<b>Subject:</b> VARIOUS AUDIO SYSTEM CONCERNS WITH TUNER AND AMP UNIT (TAU)	<b>Bulletin No:</b> 09-038/13
	<b>Last Issued:</b> 12/23/2013

2014 Mazda3 vehicles (with MAZDA CONNECT) with VINs lower than JM1BM\*\*\*\*\*109600 (produced before September 1, 2013)

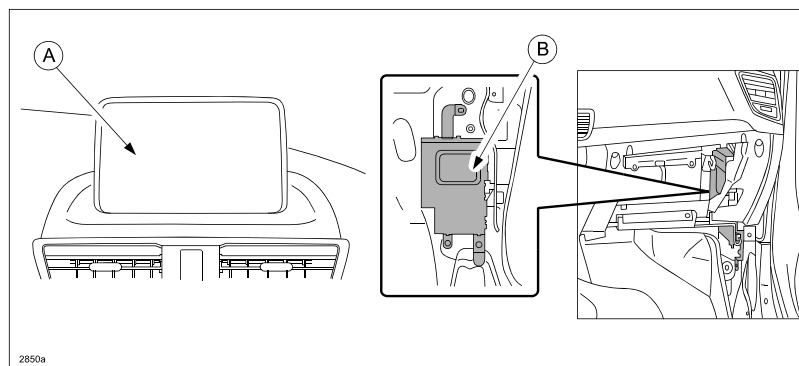
Some vehicle may experience any one of the symptoms below that can be resolved with a modified TAU.

- AM/FM/XM cannot be selected as they are grayed out
- Radio station returns to 87.9MHz on its own
- Audio sound setting resets on its own
- TAU version is displayed as "not available"

1. Verify customer concern.
2. On vehicle with a touchscreen (A), remove the TAU (B) and replace with a modified one. Refer to MS3 online instructions or Workshop manual (section 09-20 TUNER AND AMP UNIT (TAU) REMOVAL/INSTALLATION).
